Terraffic Pty Ltd

DA2023/1206 – 6 NET ROAD, AVALON BEACH PROPOSED RESIDENTIAL DEVELOPMENT

TRAFFIC ENGINEERS REFERRAL RESPONSE

Application Number:	DA2023/1206
Proposed Development:	Alterations and additions to a dwelling house including secondary dwelling
Date:	08/09/2023
To:	Brittany Harrison
Land to be developed (Address):	Lot 8 DP 232257 , 6 Net Road AVALON BEACH NSW 2107

DRAWING Driveway Plan & Section 1		Tel: 8414 466 665 Email: andy@andylehman.com.au		SCALE		DATE		Jan 2024
NOTES Please print in A3 or A1. This drawing is copyright and is for Development Application purposes only. Do not measure off drawings.		If in doubt ask.		ISSUE		A

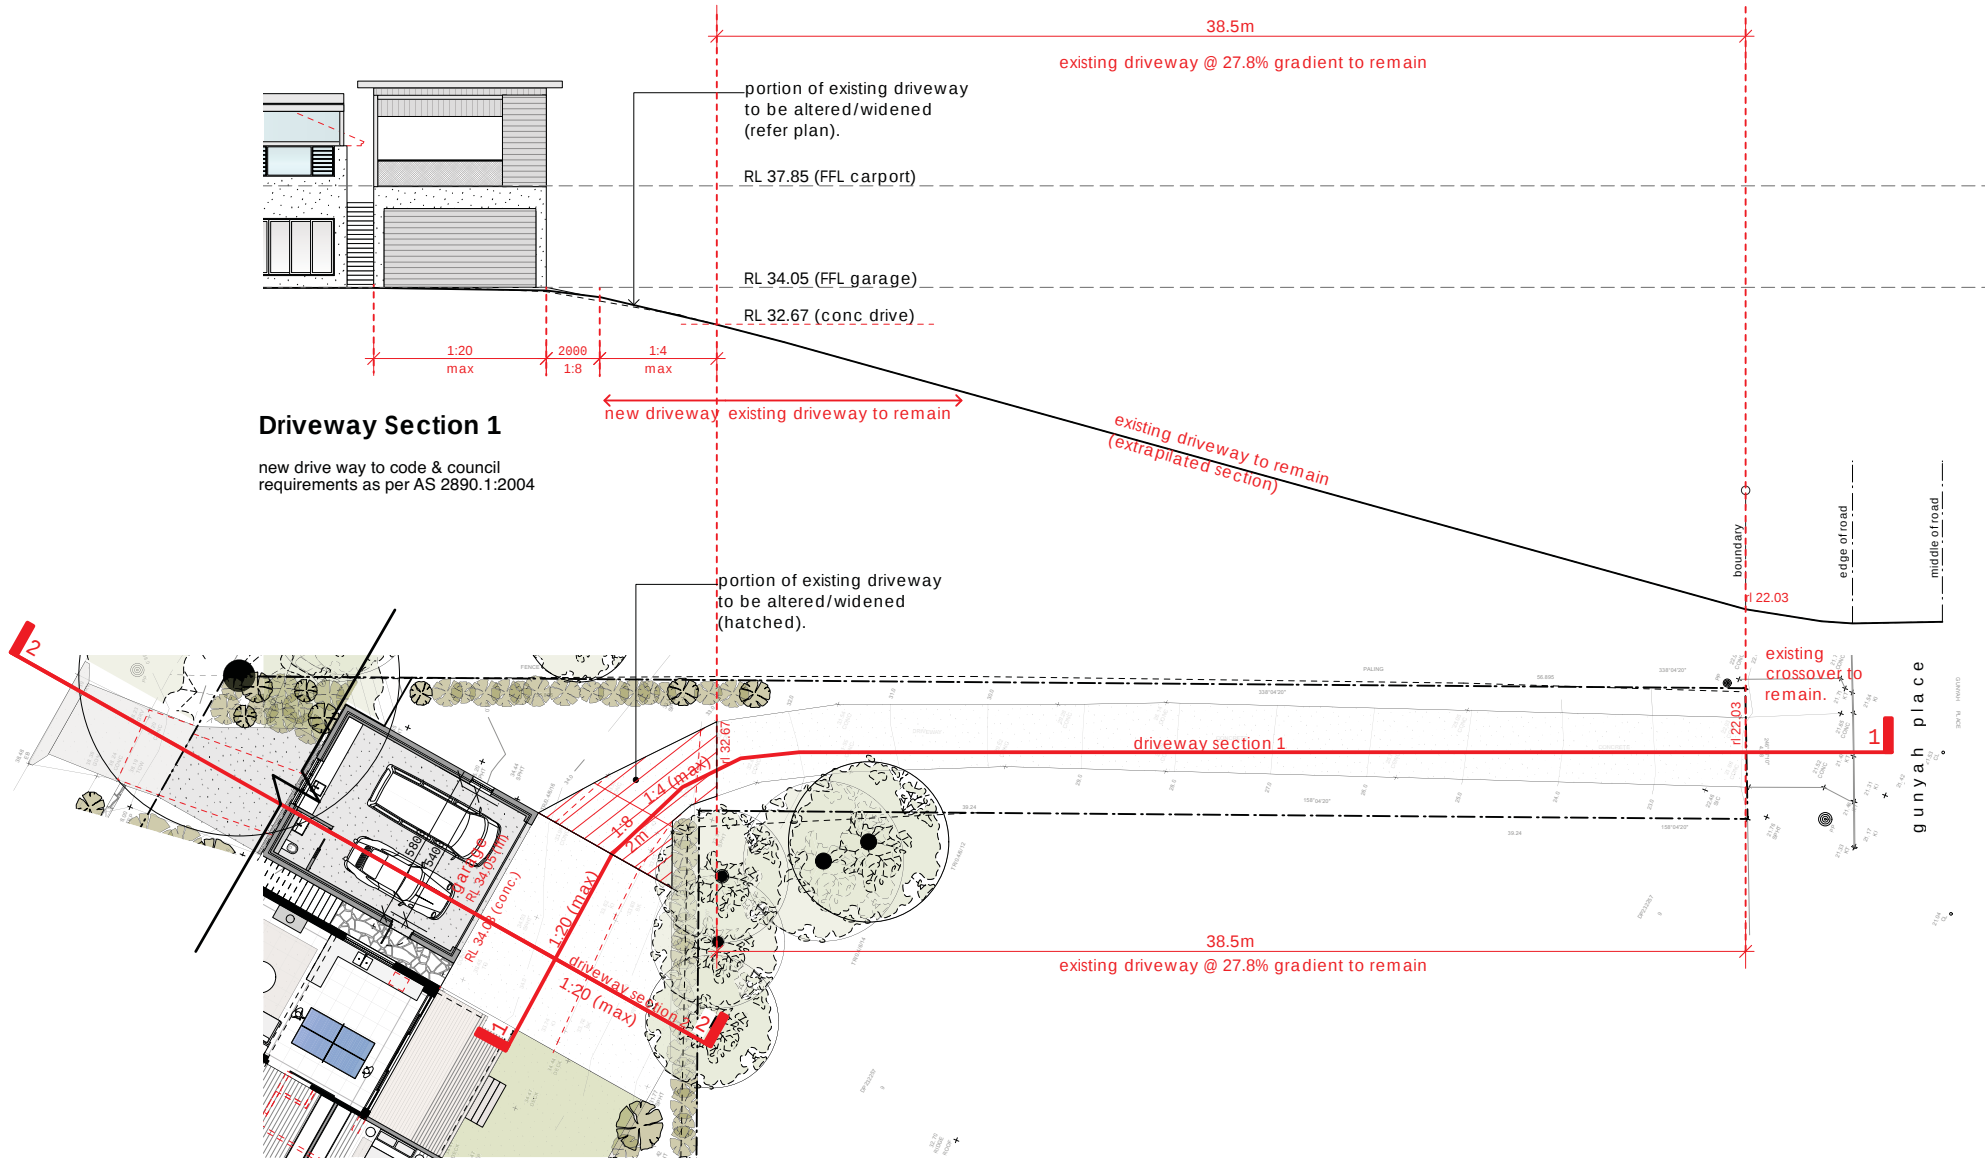
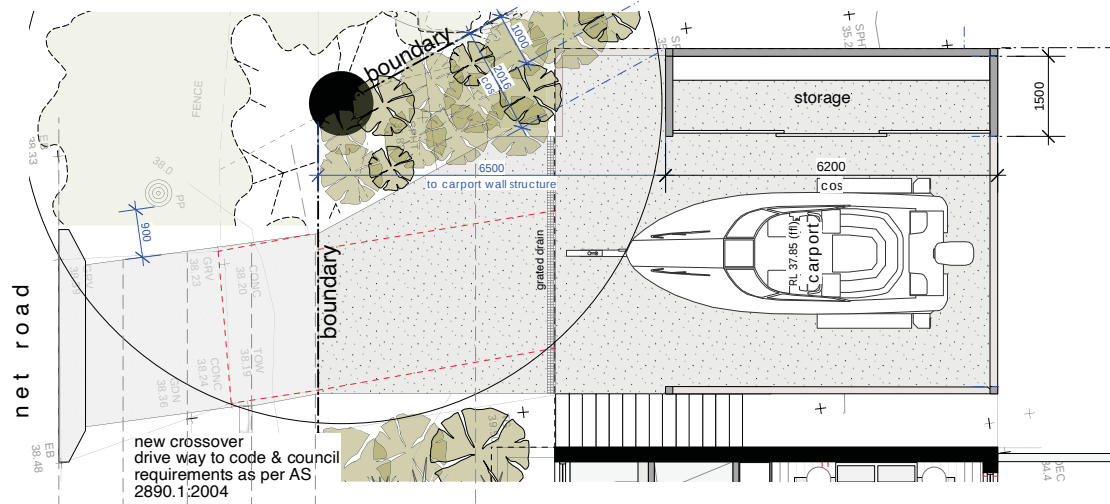
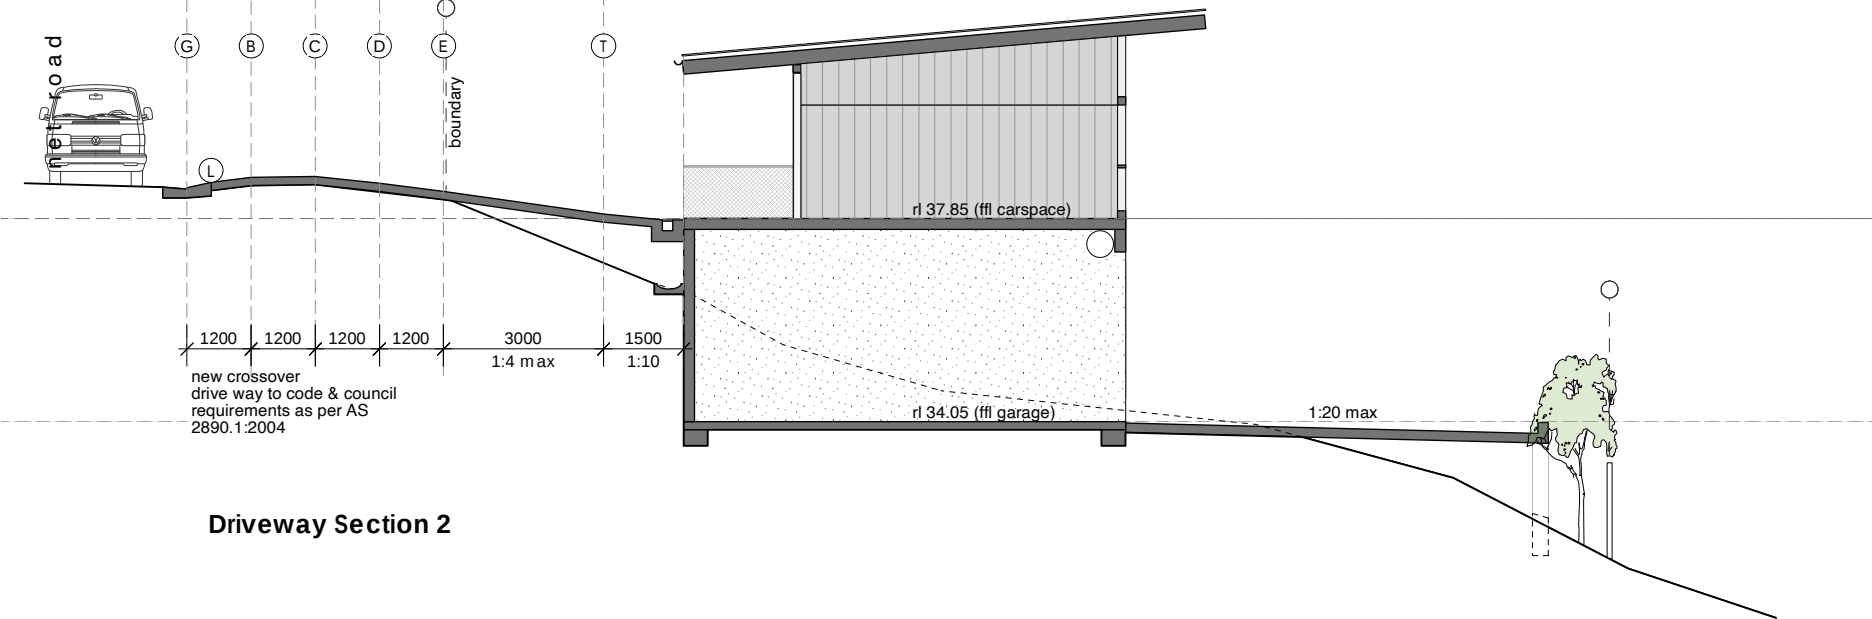
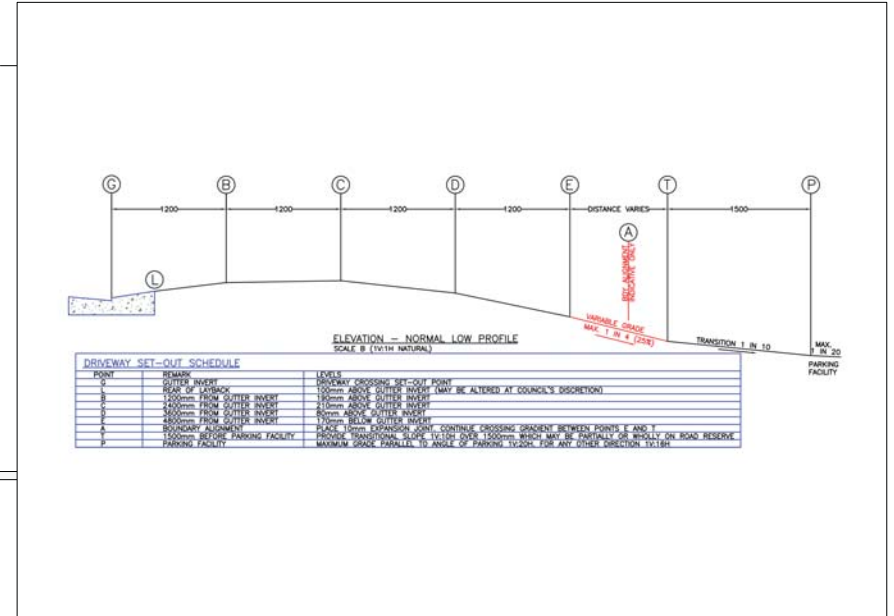
Access from Net Rd:

The proposed garage levels is RL37.85, which is approximately the same level as the boundary. There would be significant fill within the boundary to meet these levels. Details are required to be provided.

There are no proposed levels or longitudinal sections for the driveway.

Requesting 2 longitudinal cross sections on both ends of the driveway, showing existing and proposed levels commenced from the existing driveway to the end of the parking facility.

The driveway shall maintain 900mm of clearance to the Power Pole.

There should be a dish drain at the edge of the bitumen to keep runoff on the road

The existing western driveway is to be retained to provide access to a single width carport. The new carport will be at RL37.85 which is similar to the existing boundary level. The driveway will be located 900mm from the existing power pole on Net Road and will be constructed in accordance with Council's Driveway requirements. A copy of the Council's "Normal Low Profile" is reproduced in Annexure F which is likely to be adopted in this case.

**Manoeuvring Path of Australian
Standard AS/NZS2890.1:2004
B85 Vehicle Accessing Space A**

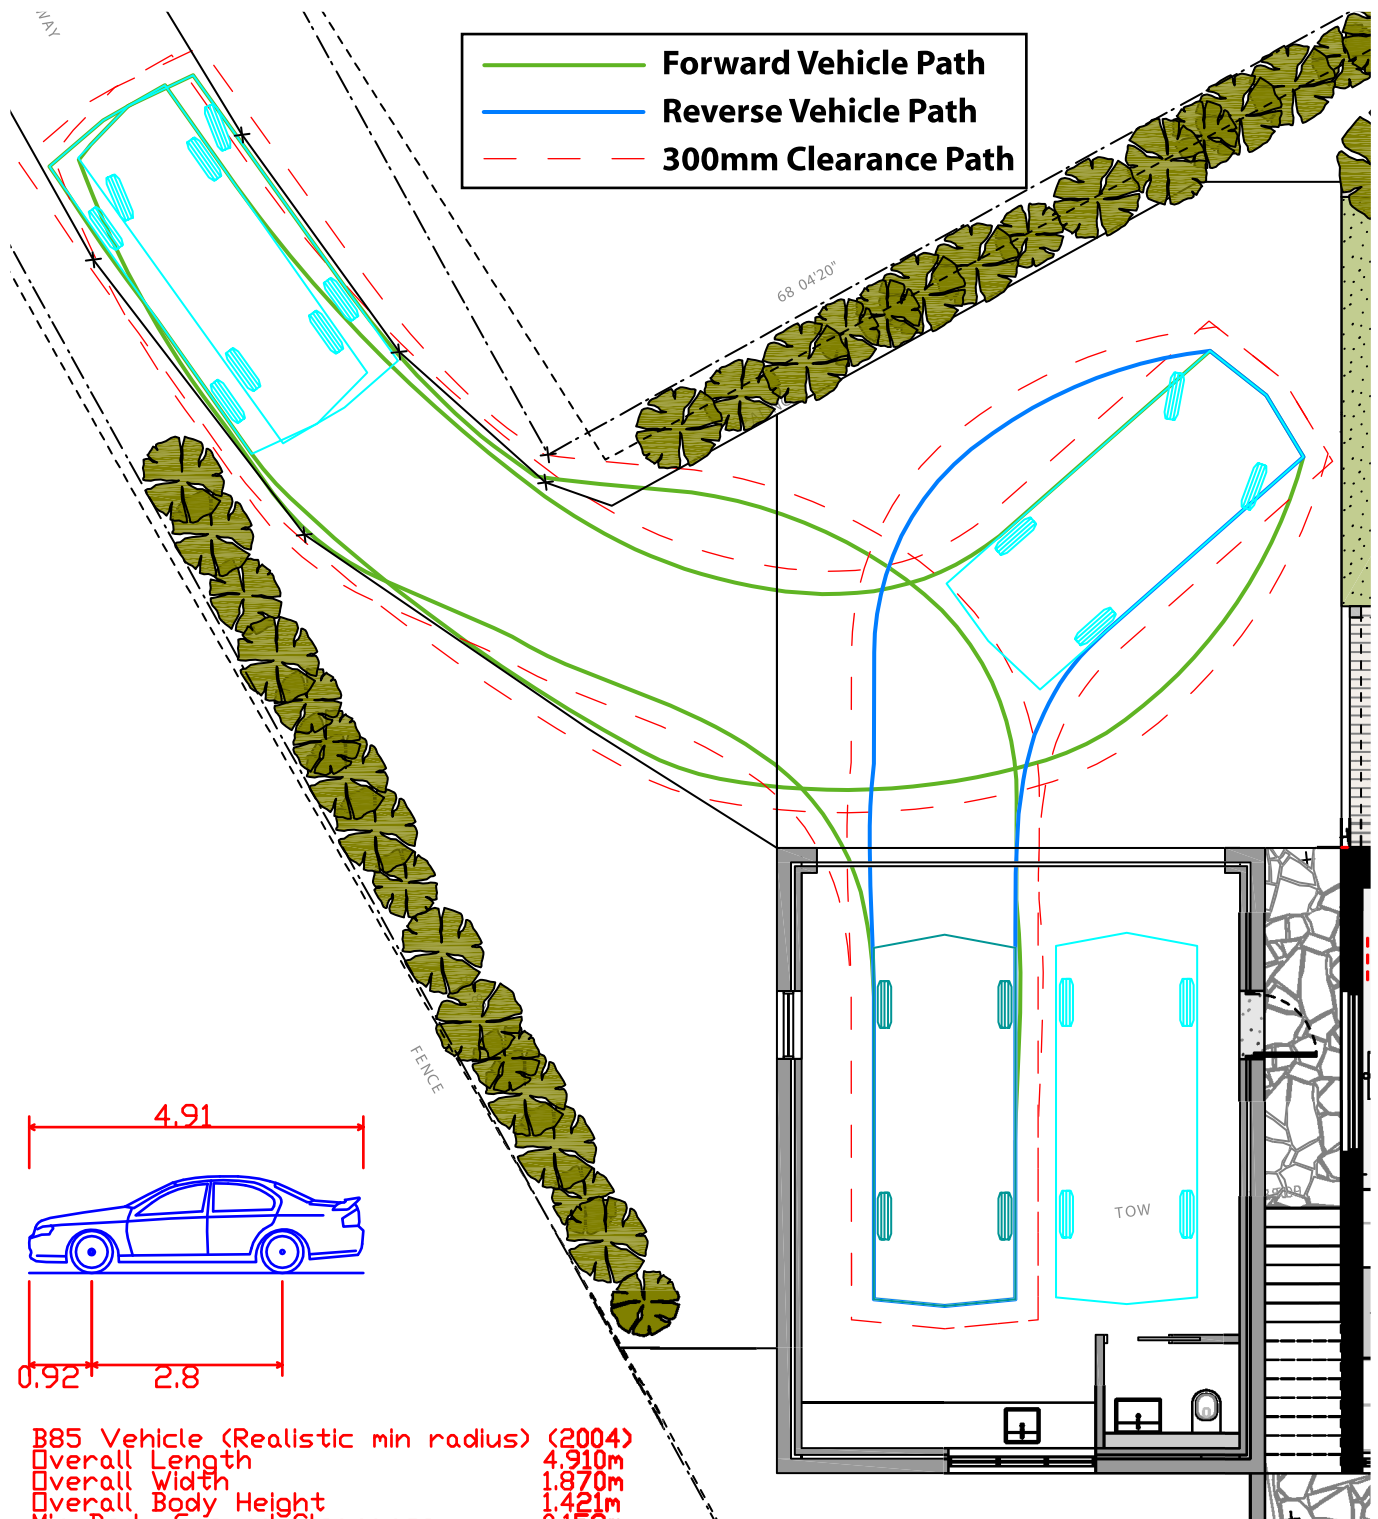
The parking facilities and driveway gradients need to be designed in accordance with AS 2890.1:2004:

facility. The profile must show that a B85 vertical clearance model can safely access the site.

The proposed double garage satisfies the dimensional requirements of the Australian Standard AS/NZS890.1:2004 with a minimum length of 6.1m and width of 5.8m. Swept paths of the B85 vehicle (Ford Falcon) accessing both spaces are reproduced in **Annexure D**. As can be seen, these vehicles can enter and exit the property in a forward direction with a maximum of 3 manoeuvres.

GUNYAH PLACE ACCESSWAY PHOTOGRAPHS

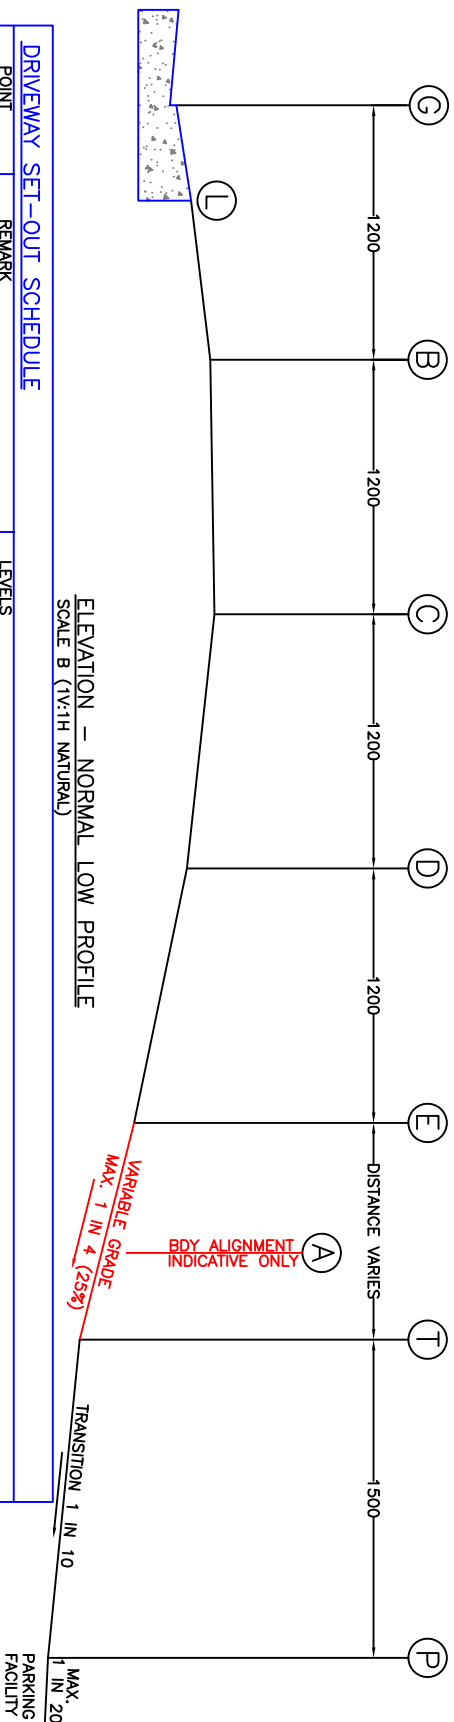
The existing driveway is extremely steep, with some sections exceeding grades of 30%.

Should the existing driveway be used, there does not seem to be sufficient transitions to prevent scraping.

Council's Engineer has raised a concern with regards to the gradient of the Gunyah Place accessway. As can be seen on the longitudinal section in Annexure B, the existing accessway is 38.5m in length and has an average grade of 27.8% (1 in 3.6) from RL22.03 at the boundary to RL32.67 prior to the manoeuvring area.

By maintaining the existing accessway, the proposal is consistent with Clause B6.2 of the Pittwater DCP which states:

For existing Internal Driveways on steeply sloping or difficult sites proposing dual occupancies, dwelling houses, secondary dwellings, exhibition homes, rural works dwellings and tourist and visitor accommodation, gradients up to a maximum of 1:3 (V:H) may be maintained subject to demonstration through a Traffic Assessment Report and the relevant certification that the Internal Driveway including surface finish is safe for its intended use.

Photographs of the existing accessway are reproduced in **Annexure E** showing the concrete surface that has been operating safely for many years.
